JI VERIFICATION REPORT

- 2ND PERIODIC –

YARA PARDIES N_2O ABATEMENT PROJECT

Report No: 8000406539 – 12/185

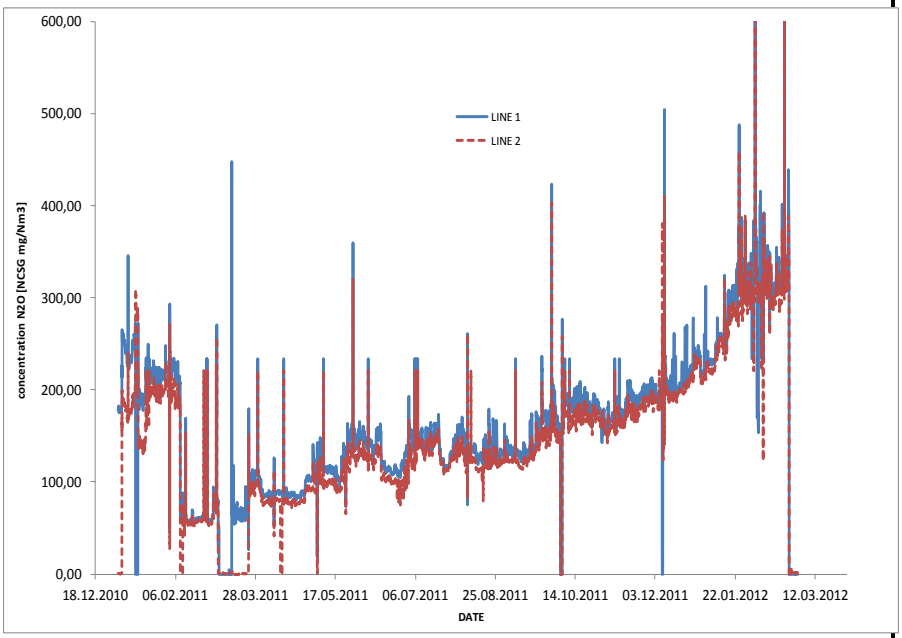
Finding:	E2		
Classification	☐ CAR	☒ CL	☐ FAR
Description of finding *Describe the finding in unambiguous style; address the context (e.g. section)*	The justification on the concentration gradient of N_2O in the stack gas during the Monitoring Period shall be further elaborated. The course shows strong depressions as well an abrupt increase of the N_2O concentration at the end of the monitoring period. The PP is requested to clarify the main reasons of the course of measured N_2O concentration (NCSG of line 1 and 2) in the stack gas over the campaign.

Finding:	E2
Corrective Action #1 *This section shall be filled by the PP. It shall address the corrective action taken in details.*	*The large fluctuations in the N_2O concentration during the monitoring period were due to the following reasons:* • *11/01/2011: high peak in N_2O emissions from line 2. Burner 1 was shut down, causing all gas to be emitted through line 2.* • *13/01/2011: Drop in emissions from line 1 due to primary catalyst gauze change and addition of extra de-N_2O catalyst* • *10/02/2011: Drop in emissions from line 2 due to primary catalyst gauze change and addition of extra de-N_2O catalyst* • *Mid Jan to end Feb 2012: Significant increase in N2O emissions due to problems with the basket seal in burner 2, which was leading to gas by-passing. The plant was shut down on 24/02/2012 in order to repair the basket. The N_2O levels have since returned to normal.*

Finding:	E2
AIE Assessment #1 *The assessment shall encompass all open issues in annex A-2. In case of non-closure, additional corrective action and AIE assessments (#2, #3, etc.) shall be added.*	The verifier concludes that the description of the relevant reasons responsible for concentration gradient of N_2O in the stack gas during the Monitoring Period is traceable. The course of NCSG over the second monitoring period is shown in the following figure. Furthermore the explanation is in accordance to the situation verified onsite via interviews with the plant staff and in accordance with plant operation history. The verifier confirms that the concentration of N_2O in the stack gas is further more in relation to (a) the mean residence time in AOR (secondary catalyst and flow velocity); (b) the conditions of precious metal gauze; (c) concentration of NOx in the stack gas flow as a function of the produced concentration and amount of HNO_3 (a part of N_2O is generated in the De-NOx reactor from NOx during the destruction process. Depending on the process parameter of the nitric acid plant and De-NOx reactor conditions different N_2O concentration can be expected.) The verifier checked during the on site audit the reasons for drops of NCSG figures and found the reasonable explanations given by the plant operator acceptable.
